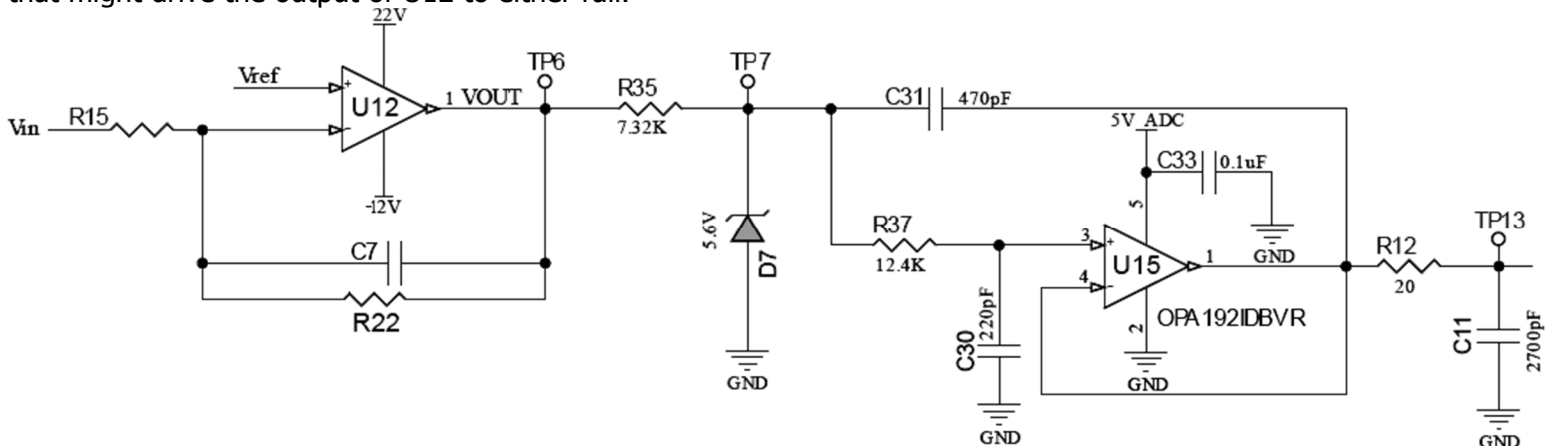
We are currently using the TI opamp OPA192IDBVR in the circuit below (U15) as a low pass filter feeding an ADC. Its input comes from an attenuator U12 with adjustable offset and gain to center the signal from 0-5V. it has been working well except we are finding issues with leakage current in D7 in some cases. The only function of D7 is to protect the +input of U15 for a momentary abnormal condition of Vin exceeding its range due to a cable short, etc that might drive the output of U12 to either rail.

Based on your [datasheet](#), we would like to know if removal of D7 would create any reliability issues given the large resistance in series with the +input. Please note that since this would be a momentary abnormal condition, expected output of U12 is not critical, only that output would be correct when inputs return to normal common mode range.

Calculated worst inputs current to +input of U15 if D7 were removed is:

- input current for U12 output at positive rail = $(22V - 5V)/(7.32k + 12.4k) = 223\mu A$
- input current for U12 output at negative rail = $(-12V)/(7.32k + 12.4k) = -609\mu A$

Given that either of these currents are well below the $\pm 10\text{mA}$ limit in the table below, can you please confirm that removal of D7 would be acceptable for our application and cause no damage to the part or long term reliability?
